## TPI LOOSENING DURING ENGINE OPERATION

### MODELS AFFECTED

All Mercury Hi-Performance 300 Pro Max/Super Magnum engines.

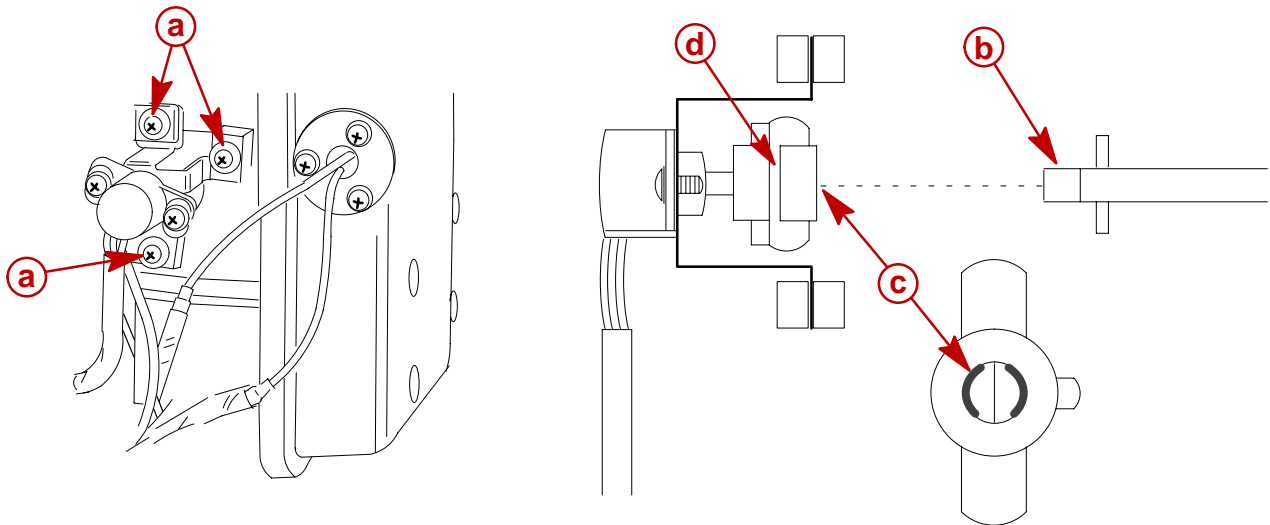
TPI setting may change during operation causing a rich or lean condition to occur.

1. Remove TPI assembly from fuel management system secured by (3) screws (a).
2. Clean throttle shaft (b) and inside of coupler (c) with a commercial cleaning solvent.
3. Apply Loctite #404 quickset to inside of coupler (c).
4. Slide coupler (c) over throttle shaft (b) and wipe off any excess Loctite.

**IMPORTANT:** When inserting coupler onto throttle shaft make sure the center portion of the coupler (d) does not glue together.

**IMPORTANT:** Once the TPI has been repaired place a yellow dot on the top surface of the TPI.
